**ATASCOCITA RECYCLING AND DISPOSAL FACILITY
HARRIS COUNTY, TEXAS
TCEQ PERMIT APPLICATION NO. MSW 1307D**

PERMIT AMENDMENT APPLICATION

Re: Atascocita Recycling and Disposal Facility - Harris County
Municipal Solid Waste (MSW) - Permit No. 1307D
Permit Amendment Application - First Notice of Deficiency (NOD)
Tracking Nos. 14452326 & 14476346; CN600127856/RN100216142

This response to the First Notice of Deficiency, addressed to Mr. Steve Jacobs, Director of Landfill Operations, dated December 14, 2010, is submitted on behalf of Waste Management of Texas, Inc. The permit amendment application has been revised as appropriate and one original and three copies are enclosed with this letter. The revision number and date are noted on each revised page and the revisions are highlighted as requested. Our responses to the Texas Commission on Environmental Quality (TCEQ) staff comments are presented below in the order received.

j:\101\17\102\2010-FINAL\Part II\IIA.5-GasWells.dwg Layout: Layout1 User: scundh

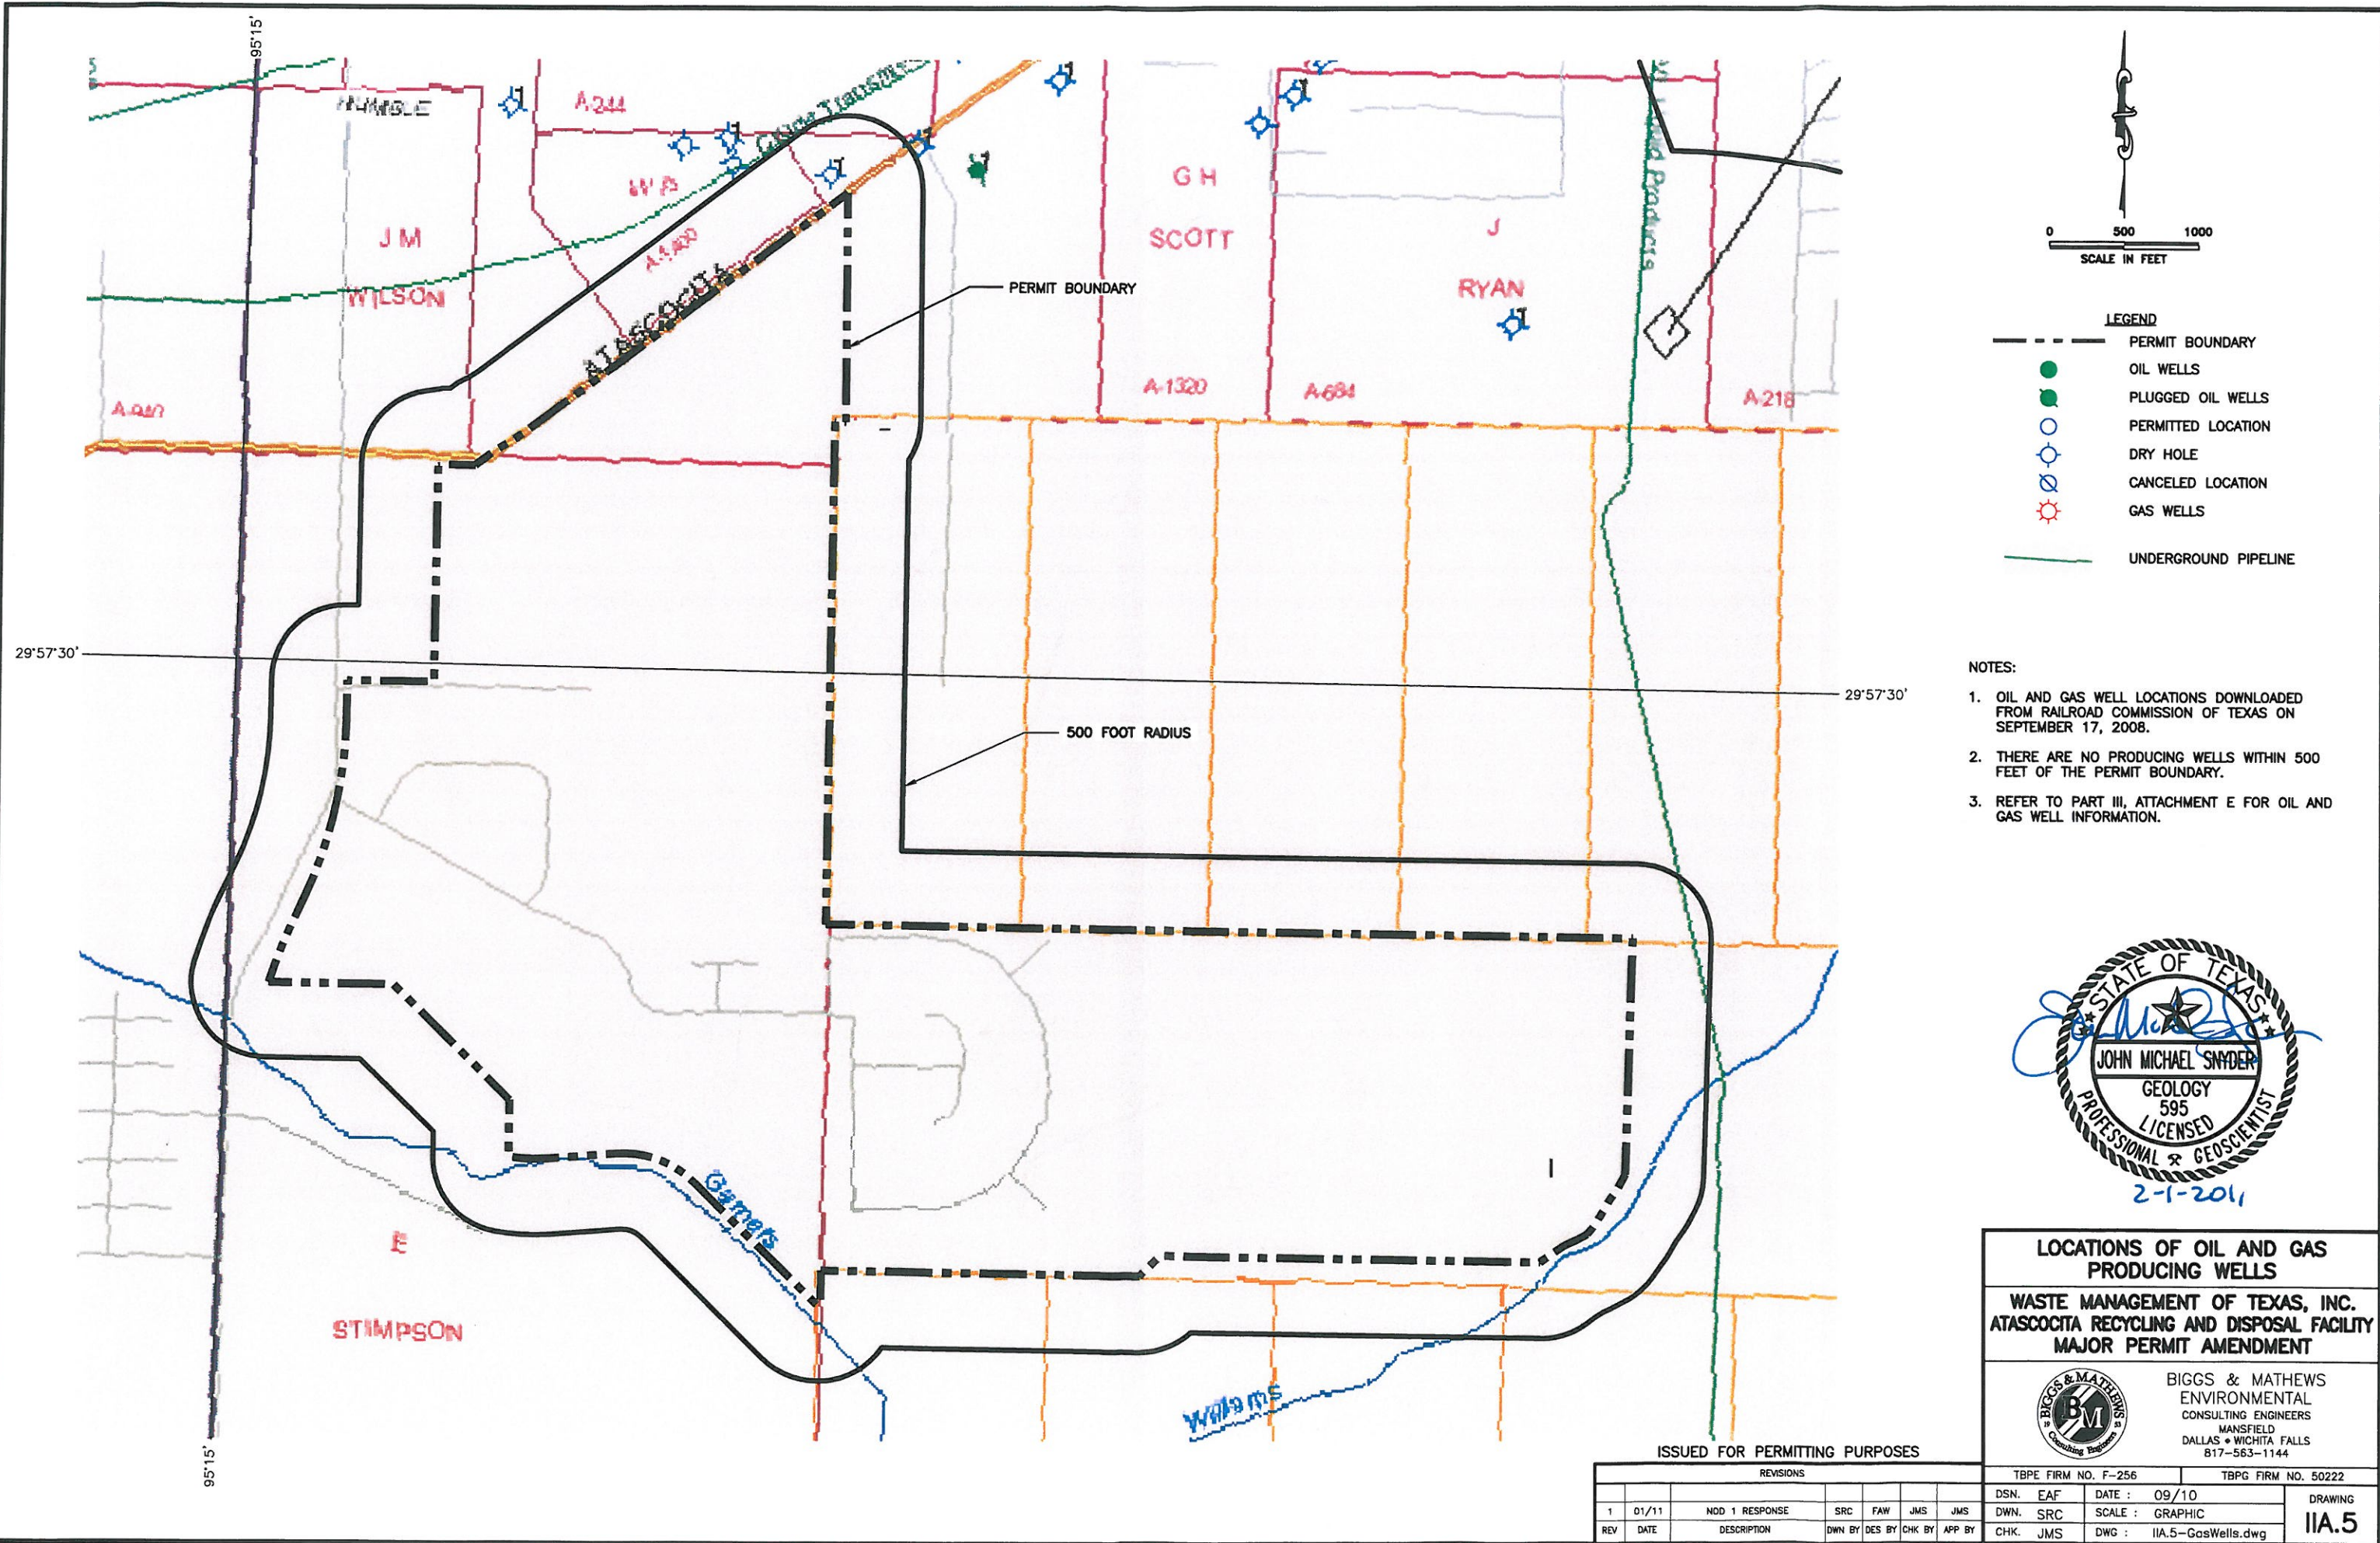
54. Some of the symbols and labels on Drawing IIA.5 (Locations of Oil and Gas Producing Wells) are not readable. Please revise Drawing IIA.5 (and Figure E4-2 in Appendix E4 of Part III, Attachment E, which presents the same information) so that all information is legible. Please also reference Drawing IIA.5 in Section 12.2 of Part II.

RESPONSE: As requested, Part II, Drawing IIA.5 has been revised for clarity. Part II, Section 12.2 has been revised to include a reference to Drawing IIA.5.

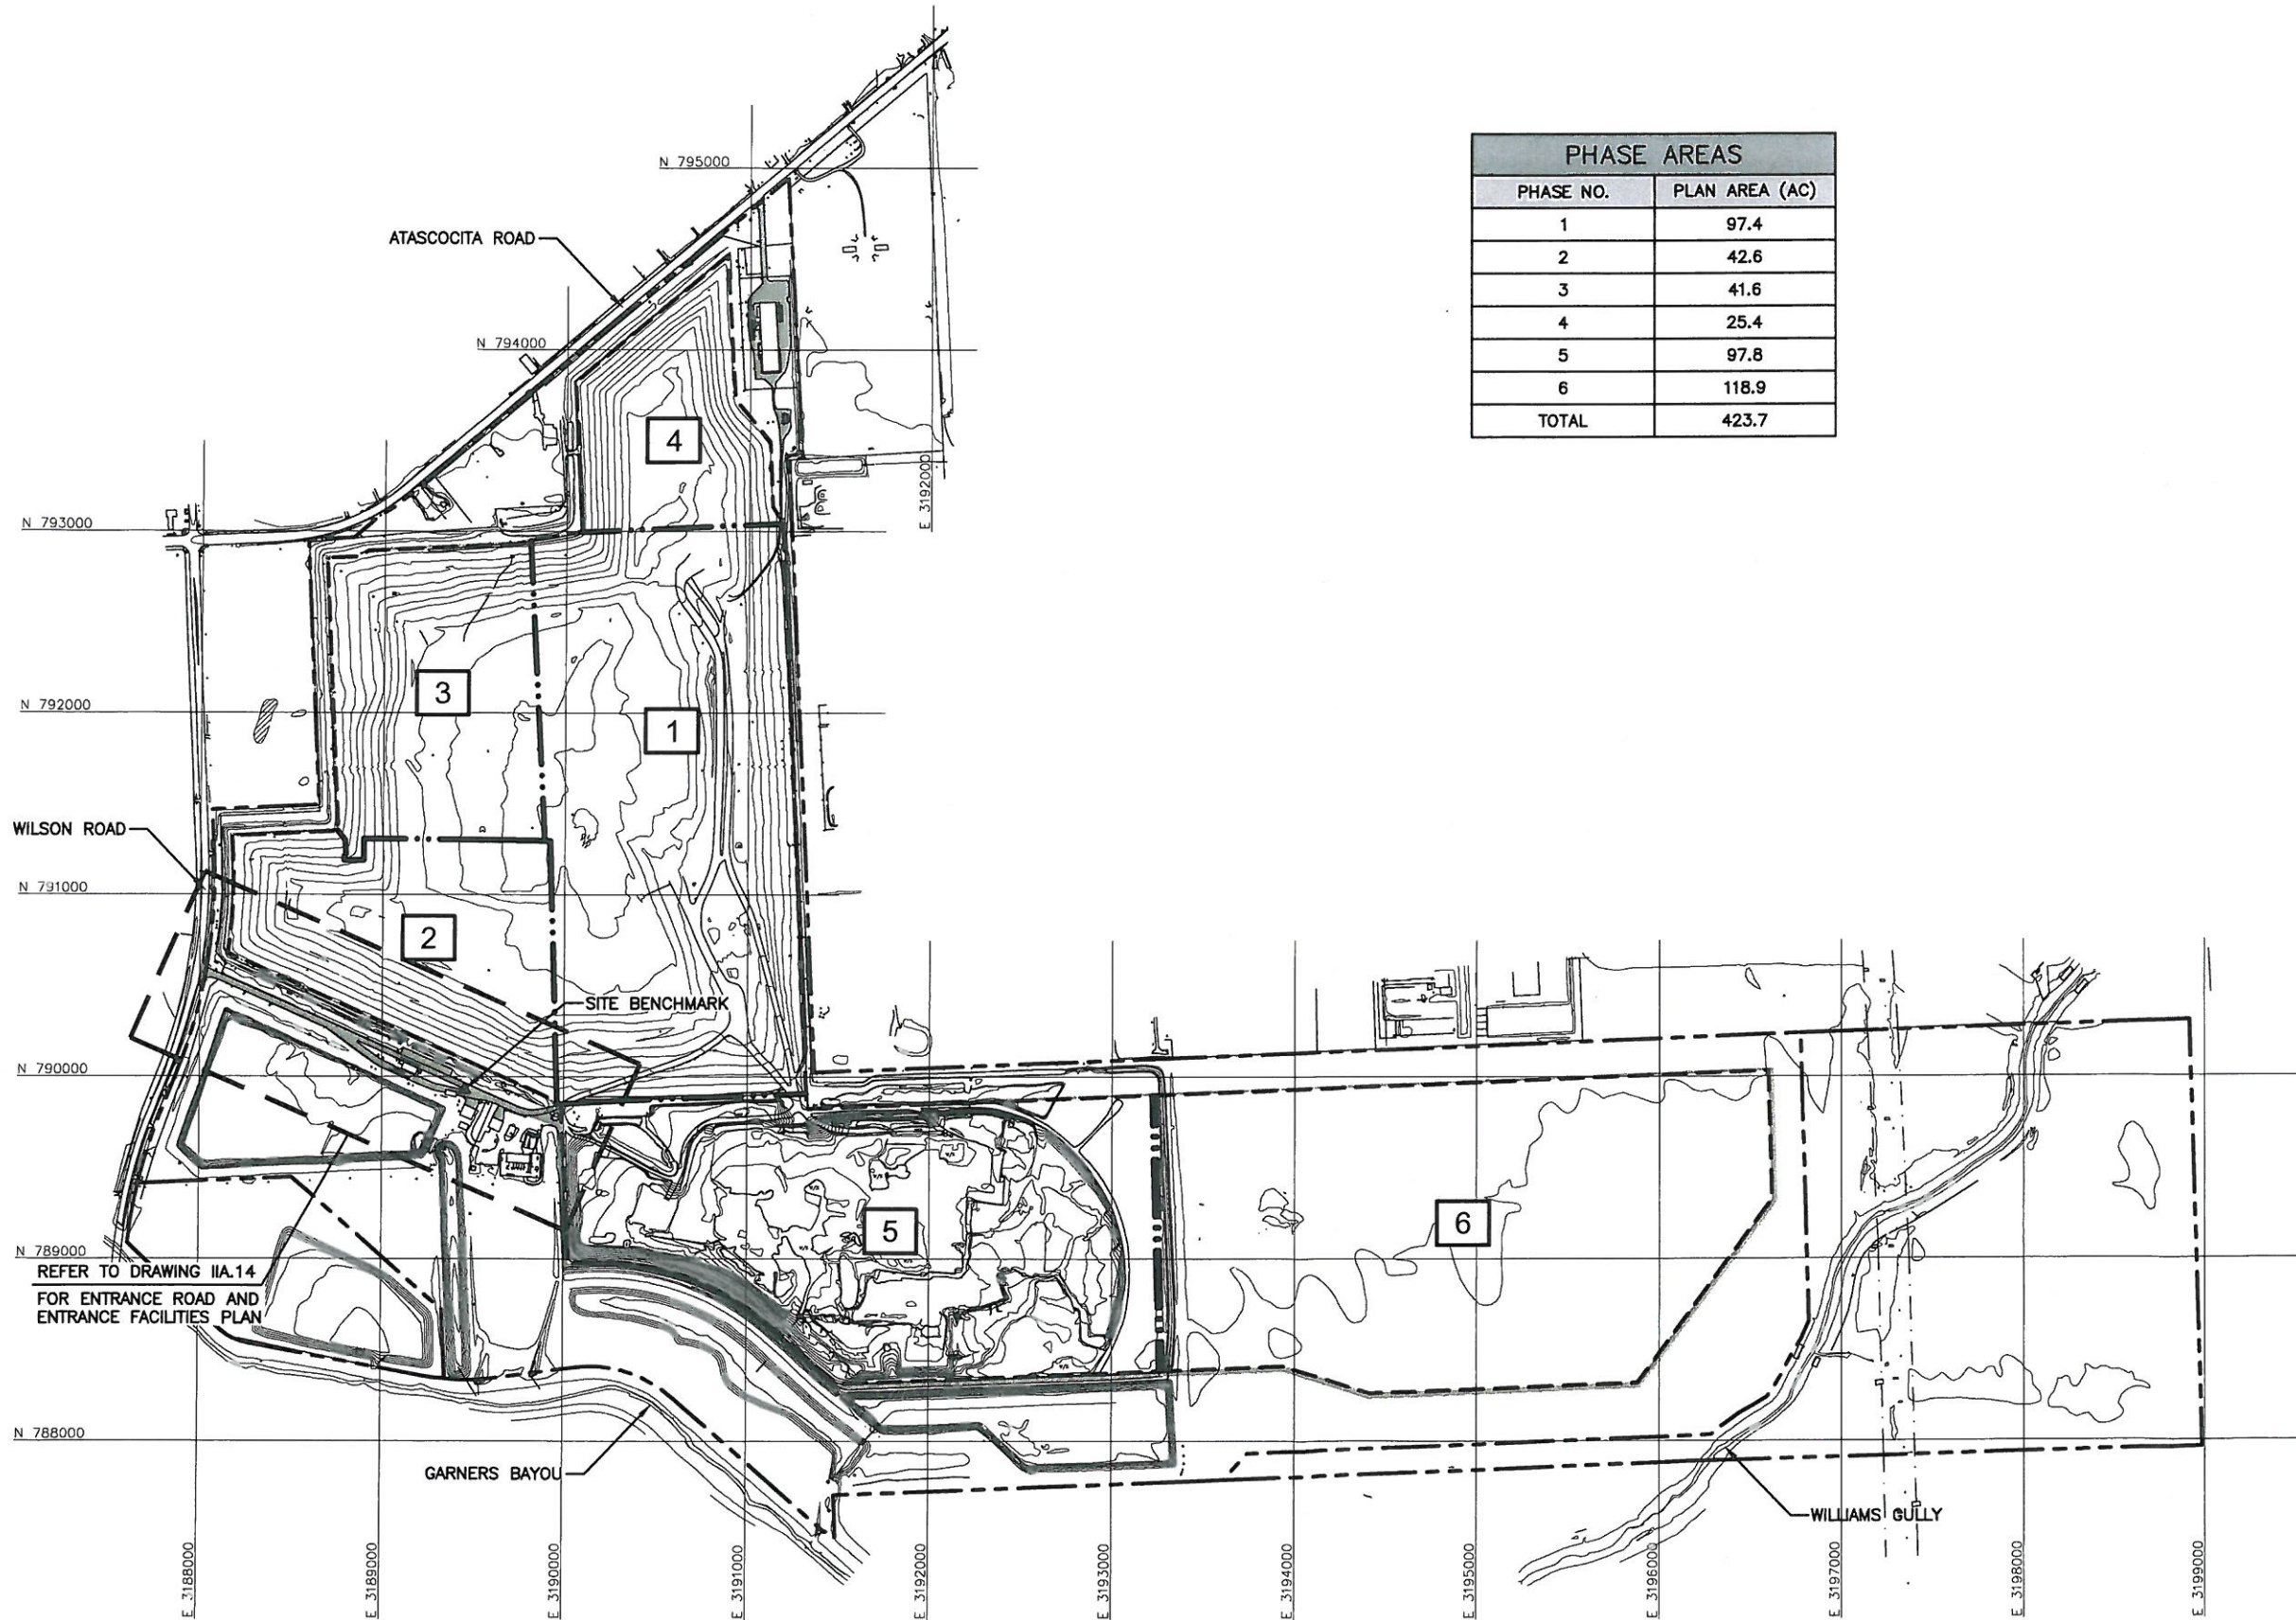
42. The coordinates of the permanent facility benchmark are noted on Drawing IIA.8 (General Site Plan), however, we could not find the benchmark on the drawing. Please verify that the benchmark is included on the drawing, and provide a prominent label to help locate the feature.

RESPONSE: *As requested, Part II, Drawing IIA.8 has been revised to include the location of the permanent facility benchmark.*
